L-11-141

Beaver Valley Power Station, Unit Nos. 1 and 2 BVPS-1 Docket No. 50-334, License No. DPR-66 BVPS-2 Docket No. 50-412, License No. NPF-73 License Amendment Request No. 10-021, Replacement of Beaver Valley Power Station Unit No. 1 Spray Additive System by Containment Sump pH Control System

FENOC Evaluation of Proposed Changes

Subjeo	:	License Amendment Request 10-021, Replacement of Beaver Valley Power Station Unit No. 1 Spray Additive System by Containment Sump pH Control System. Changes Proposed to Technical Specifications 3.6.8 and 3.6.9.	
		Table of Contents	
1.0	SU	MMARY DESCRIPTION	2
2.0	DE	TAILED DESCRIPTION	2
3.0	ΤE	CHNICAL EVALUATION	3
	3.1	Background	3
	3.2	Sodium Tetraborate Evaluation	4
	3.3	Technical Specification Changes	9
4.0	RE	GULATORY EVALUATION	11
	4.1	No Significant Hazards Consideration Analysis	11
	4.2	Applicable Regulatory Requirements/Criteria	13
	4.3	Precedent	14
	4.4	Conclusions	14
5.0	ΕN	VIRONMENTAL CONSIDERATION	14
6.0	RE	FERENCES	14

Beaver Valley Power Station, Unit Nos. 1 and 2 Proposed Technical Specification Changes

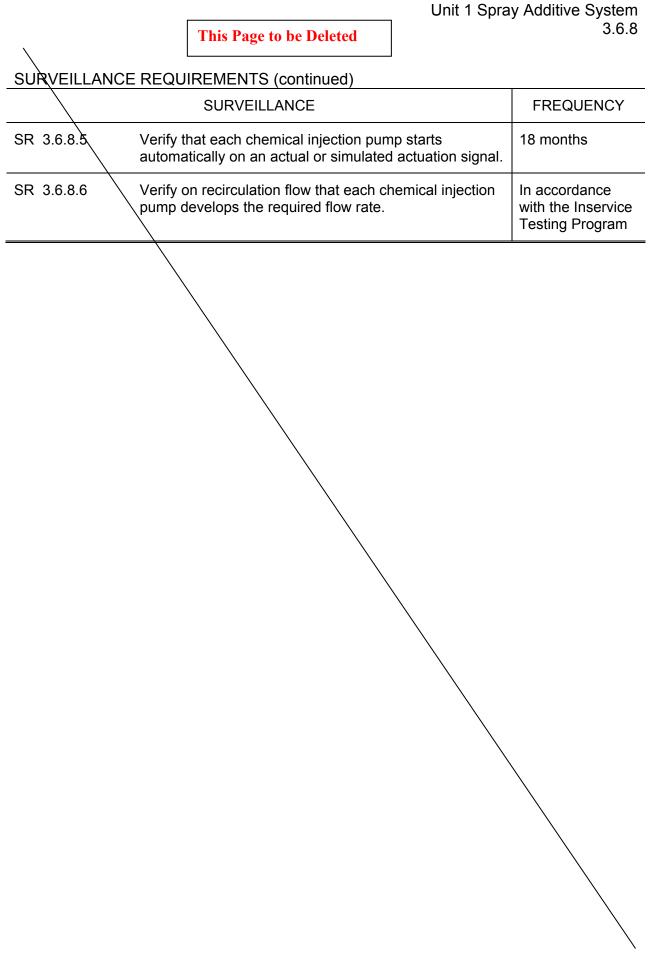
3.6.8 - 1
3.6.8 - 2
3.6.9 - 1

Unit 1 S	Spray Additive S	System 3.6.8
	MENT SYSTE Spray Additive	_	This Page to With Page 3.6.		
LCO 3.6.8	The Spra	y Additive System s	hall be OPERABLE	Ξ.	
	MODES	1, 2, 3, and 4.			
ACTIONS CONDITI		REQUIRE	D ACTION	COMPLETION

A. Spray Additive inoperable.	e System		Spray Additive	72 hours	
B. Required Actic associated Co Time not met.		B.1 Be in MO		6 hours	
		B.2 Be in MO	DE 5.	84 hours	
SURVEILLANCE	REQUIREMI	ENTS			
	SUF	RVEILLANCE		FREQUE	ENCY
SR 3.6.8.1	automatic val	oray additive manua ve in the flow path th erwise secured in p	nat is not locked,	, , , , , , , , , , , , , , , , , , ,	
SR 3.6.8.2	Verify spray a ≥ 4700 gallon	dditive tank solution s.	volume is	184 days	
SR 3.6.8.3	• • •	dditive tank NaOH s d $\leq 20\%$ by weight.	solution concentration	on 184 days	
SR 3.6.8.4	path that is no	oray additive automa ot locked, sealed, or ates to the correct p uation signal.	otherwise secured	in 🔪

3.6.98 Unit 2 Containment Sump pH Control System

LCO 3.6.98 The Containment Sump pH Control System shall be OPERABLE.

SURVEILLANCE	FREQUENCY
SR 3.6. 9 8.1	Perform a visual inspection of the six sodium tetraborate storage baskets to verify the following:	18 months
	a. Each storage basket is in place and intact; and,	
	 b. Collectively contain ≥ 292 cubic feet of sodium tetraborate. b. Collectively contain ≥ 188 cubic feet of sodium tetraborate (Unit 1) ≥ 292 cubic feet of sodium tetraborate (Unit 2). 	
SR 3.6. 9 8.2	Verify that a sample from the sodium tetraborate baskets provides adequate pH adjustment of containment sump borated water.	18 months
